2021 LAND DEVELOPMENT CODE AMENDMENTS II

Amendment Report to the Board of Trustees

October 22, 2021

Prepared by: Development Services Department and Engineering Department

Figure 6-306.H.1

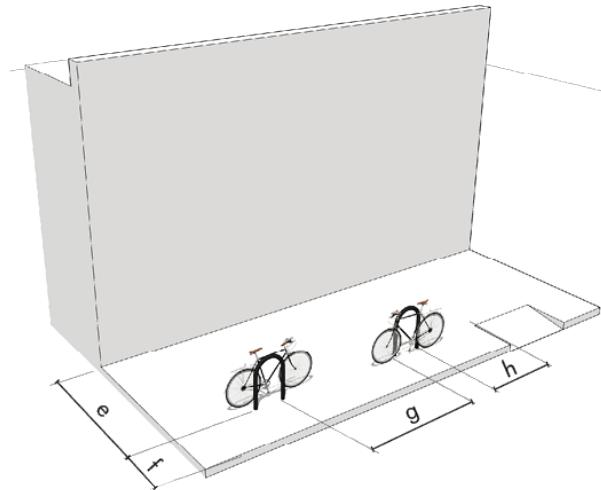
5. Bicycle racks shall be installed in conformance with the minimum spacing requirements shown in Figure 6-306.H.1.

- a. 7'-0" minimum from interior edge of sidewalk.
- b. 3'-0" minimum from rack to back of curb.
- c. 3'-0" minimum between centerline of racks.
- d. 5'-0" minimum from centerline of rack to other site elements.

- e. 5'-0" minimum from interior edge of sidewalk.
- f. 3'-0" minimum from rack to back of curb.
- g. 0'-0" minimum between racks.
- h. 5'-0" minimum from rack to other site elements.

Figure 6-208.H.1

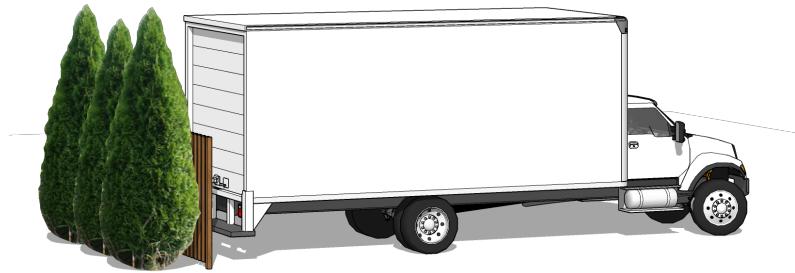
2. **Outside storage of Automobiles and Commercial Vehicles and Trucks shall be prohibited except as follows:**
 - a. **Parking of Automobiles as permitted by the Off-Street Parking regulations in Section 6-306 herein.**
 - b. **Temporary parking of Commercial Vehicles and Trucks in loading areas designed and designated for such purposes and for the purpose of loading and unloading.**
 - c. **Parking of Commercial Vehicles or Trucks essential to the operation of a business located on the same lot and with each Commercial Vehicle or Truck not to exceed 19,500 pounds. Outside storage of such vehicles shall comply with Sections 6-208.B.12, Section 208.H.1, and Section 6-308.J unless a special use is granted as per Section 6-208.C.9 herein.**
